GOVERNMENT OF INDIA
MINISTRY OF ENVIRONMENT & FORESTS
Central Zoo Authority

F. No. 19-39/92-CZA(298)(Vol. V)(M)/5143

Sub: Proposed designs for the construction of various enclosures at Lucknow Zoological Garden, Lucknow.

DRG TITLE- PLAN, ELEVATION & DETAILS	BUILDING - LEOPARD CAT ENCLOSURE			DEALT BY - Ar. Pradeep	ARCHITECT - Ranjan Shukla B.Arch. A.I.I.A. 09261473	CONCEPT BY - R.S. BHADAURIA I.F.S. (Retd.) . LUCKNOW	DRG NO. 02/03

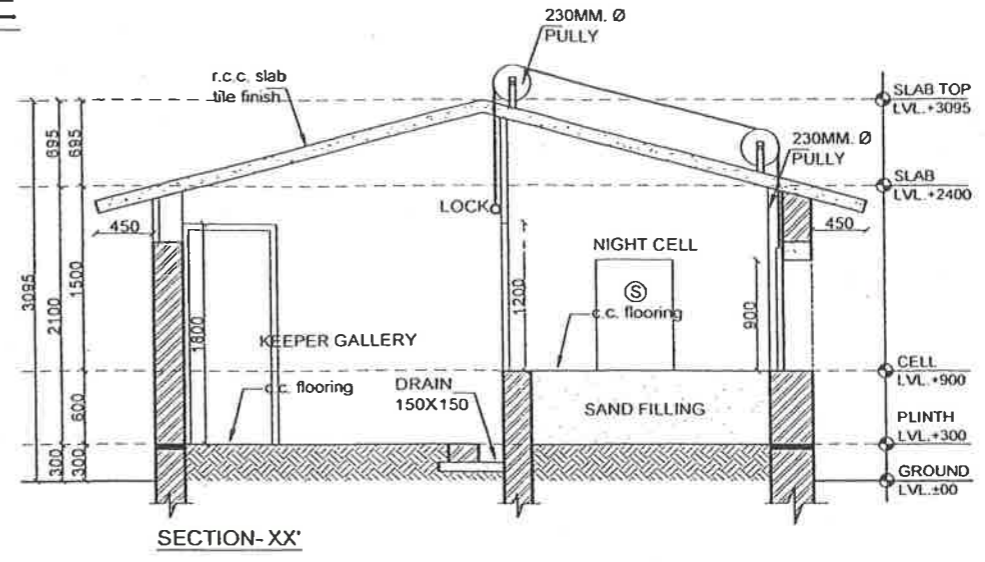
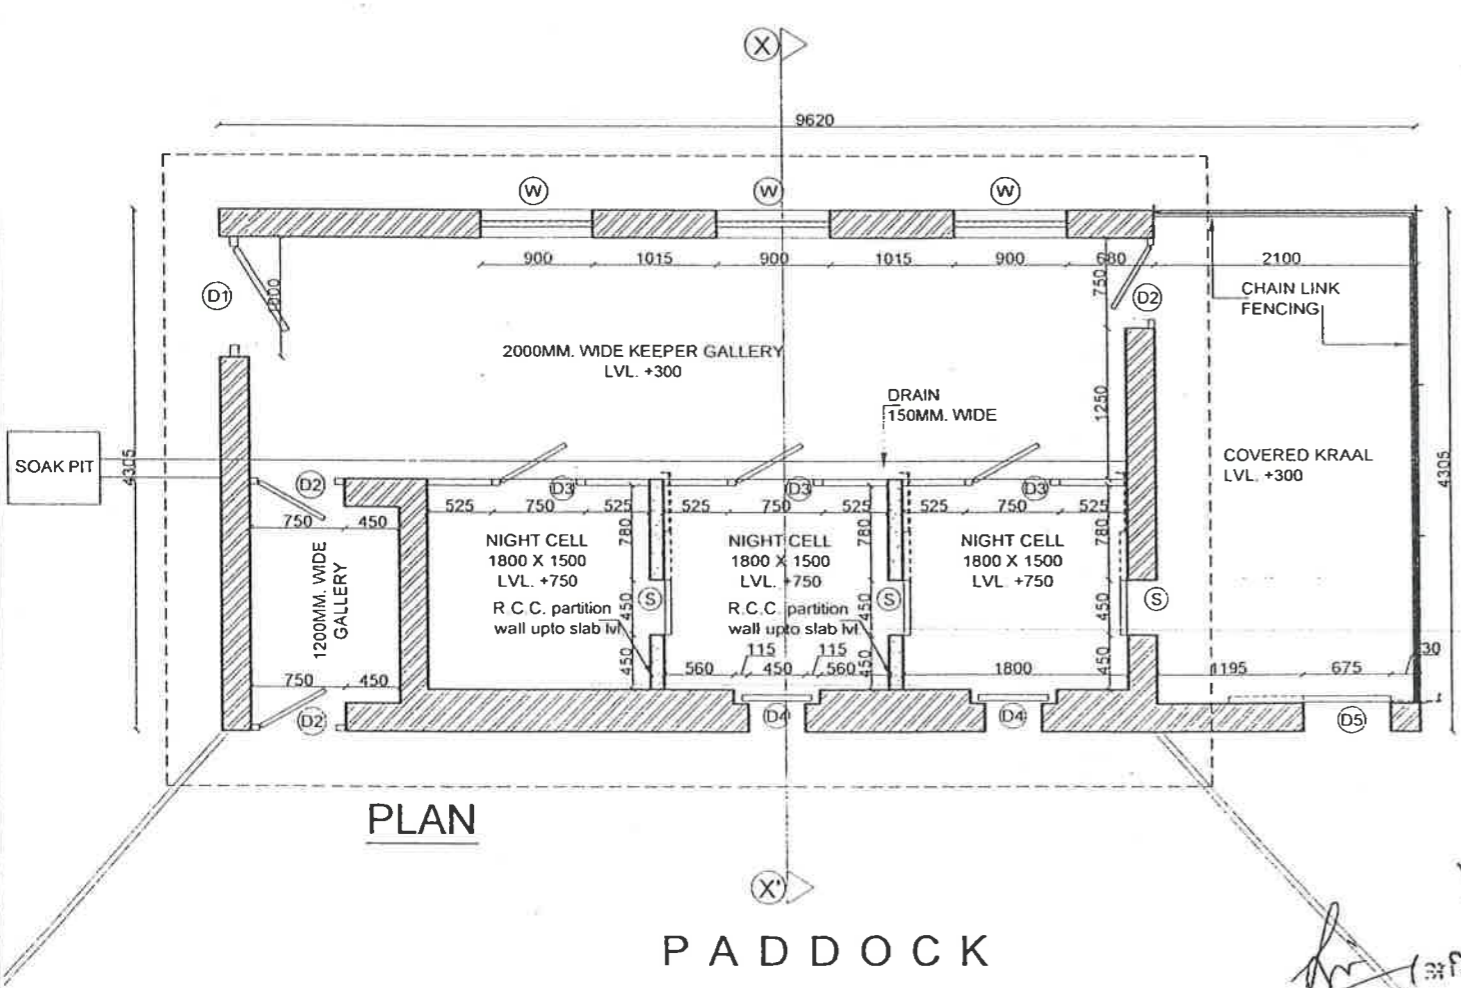
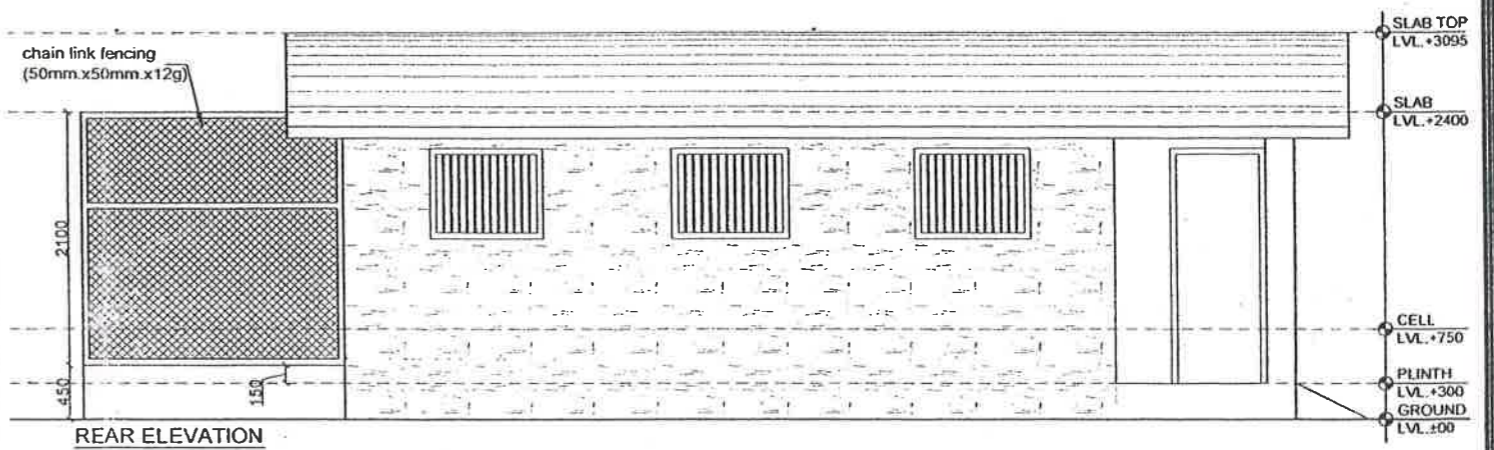
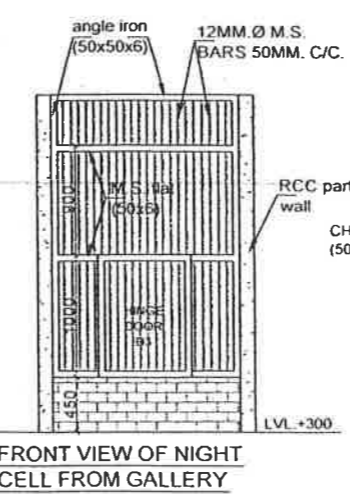
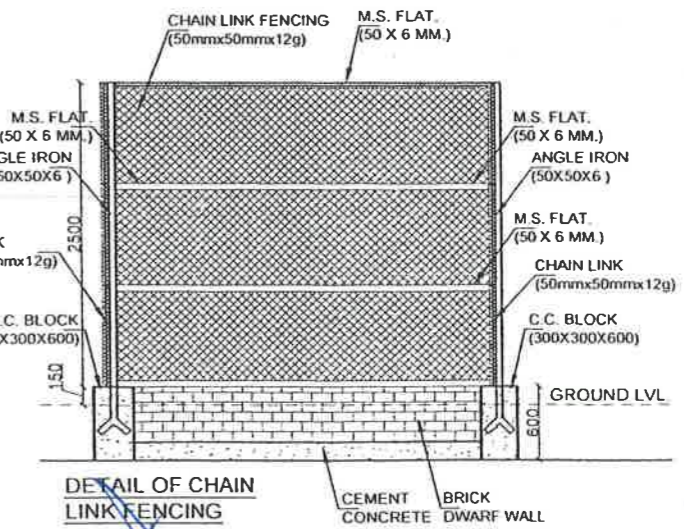
e. Enclosure for Leopard Cat

The design was scrutinized and approved.
